April 22, 2005

Docket No. 50-271  
BVY 05-046  
TAC No. MC0761

Subject: **Vermont Yankee Nuclear Power Station**  
**Technical Specification Proposed Change No. 263 – Supplement No. 28**  
**Extended Power Uprate – Response to Request for Additional**  
**Information**

**RESPONSE TO REQUEST FOR ADDITIONAL INFORMATION  
RELATED TO EXTENDED POWER UPRATE REQUEST  
VERMONT YANKEE NUCLEAR POWER STATION**

Figure SPLB-A-14-1

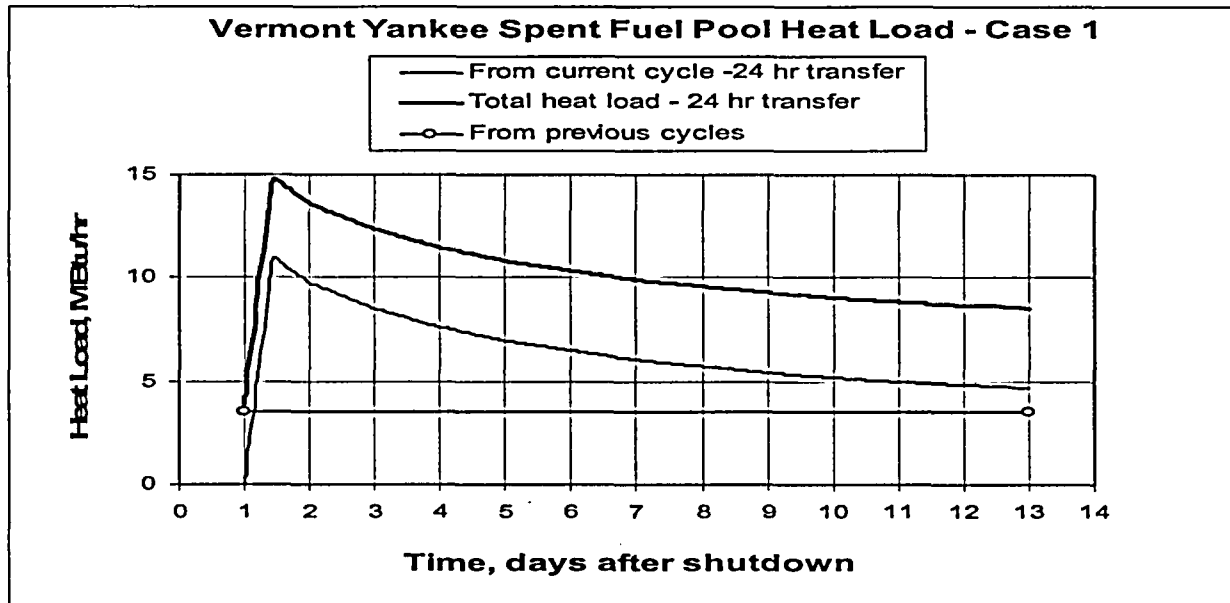
During a conference call between the NRC staff, Entergy and GE on April 13, 2005, a question was raised by the NRC staff regarding a previous RAI response which indicated that the SFP heat load at 6 days following plant shutdown was 14.8 M BTU/hr. A review of previous VYNPS RAI responses indicated that the 14.8 M BTU/hr value is shown in Entergy's response to RAI SPLB-A-9 (Section (a)(ii) on page 20 of 39 of Attachment 2 to BVY 04-074, dated July 30, 2004). It should be noted that the conservative value of 14.8 M BTU/hr used in the alternate cooling system evaluation is the maximum SFP heat load that occurs following a batch off-load for Configuration 1 shown in Table 6-3 of the VYNPS PUSAR, NEDC-33090P. Configuration 1 is an assumed scenario that differs from the scenario postulated in SPLB-A-11<sup>1</sup>. For Configuration 1, the maximum SFP heat load occurs at 35 hours (1.458 days) following plant shutdown. The actual SFP heat load for Configuration 1 shown in Table 6-3 of the VYNPS PUSAR at six days following plant shutdown is 10.34 M BTU/hr. The following Figure SPLB-A-

14-1 and Table SPLB-A-14-2 show the actual SFP heat load for Configuration 1 shown in Table 6-3 of the VYNPS PUSAR. Note that Case 1 and Configuration 1 are the same.
